***Development Special Use Permit #2015-0003***  
***5801 & 5815 Duke Street – Landmark Mall***

<b>Application</b>	<b>General Data</b>
<b>Project Name:</b> Landmark Mall	PC Hearing: June 2, 2015
	CC Hearing: June 13, 2015
	DSUP Expiration: June 13, 2018
<b>Location:</b> 5801 and 5815 Duke Street	Mall Site Acreage: 51.46 AC Plan Acreage: 11.20 AC
	Zone: CRMU-M
	Proposed Use: Retail center and multifamily residential
<b>Attorney:</b> Jonathan P. Rak, McGuire Woods, LLP  <b>Applicant:</b> Howard Hughes Corp.	Dwelling Units: 400 Units Maximum Retail: 334,909 Sq. Ft. Maximum
	Floor Area: 767,000 Maximum
	Small Area Plan: Landmark -Van Dorn Corridor Plan

<b>Purpose of Application</b>
The purpose of this application is to increase the amount of floor area of the previously approved Development Special Use Permit (DSUP #2013-0004) to allow for additional residential and commercial space. There will be approximately 36,660 additional sq. ft. of residential and 18,000 additional sq. ft. of flexible space to be used either for residential and/or commercial, pending final design reviewed with the final site plan.

2013 Second Story Floor Plan

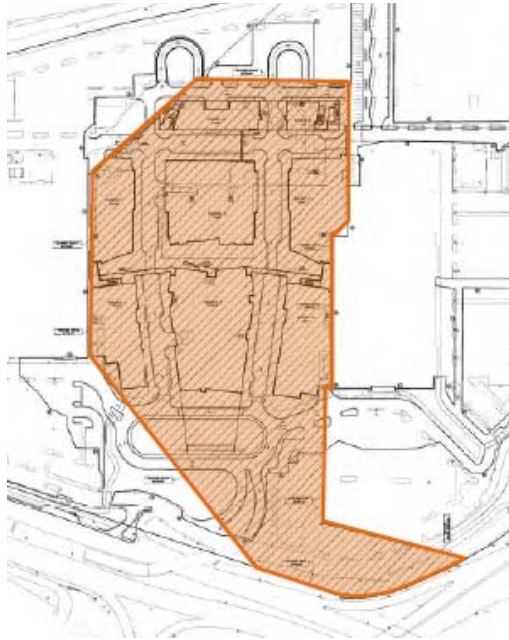
This proposal requesting the additional floor area will impact a portion of the development's overall second story residential amenity space. Building C1 and D building's configuration will change with this proposal. Areas in green are the second story residential amenity spaces as proposed in 2013. Building C1 has approximately 7,100 sq ft of courtyard while Building D has approximately 6,500 sq ft of courtyard space.

The proposed new configuration with the second floor amenity spaces are shown in white. The new configuration of Building's C1 courtyard is longer and narrower, resulting in a loss of approximately 1,700 sq ft of space. Building D's new configuration which encloses the courtyard will result in a loss of 2,730 sq ft of courtyard space. The new sizes of the reconfigured spaces, while smaller are still of an ample size to provide areas for residential activities such as outdoor grilling, swimming and other activities. Bldg. C1 =  $90 \times 60 = 5,400$   
Bldg. D =  $55 \times 70 = 3,800$  (4,430 total sq ft reduction)

When calculating the ground level open areas and the residential amenity spaces the overall percentage of open space will be approximately 33% of the redevelopment site and is a slight reduction from the 2013 approval due to the reconfiguration of Buildings C1 and D. This percentage does not meet the CRMU-M Zone District's 40% required minimum and will require a modification.

Staff supports the open space modification as the combined total of newly created open space on the greater mall site is approximately 41% and exceeds that 40% requirement.
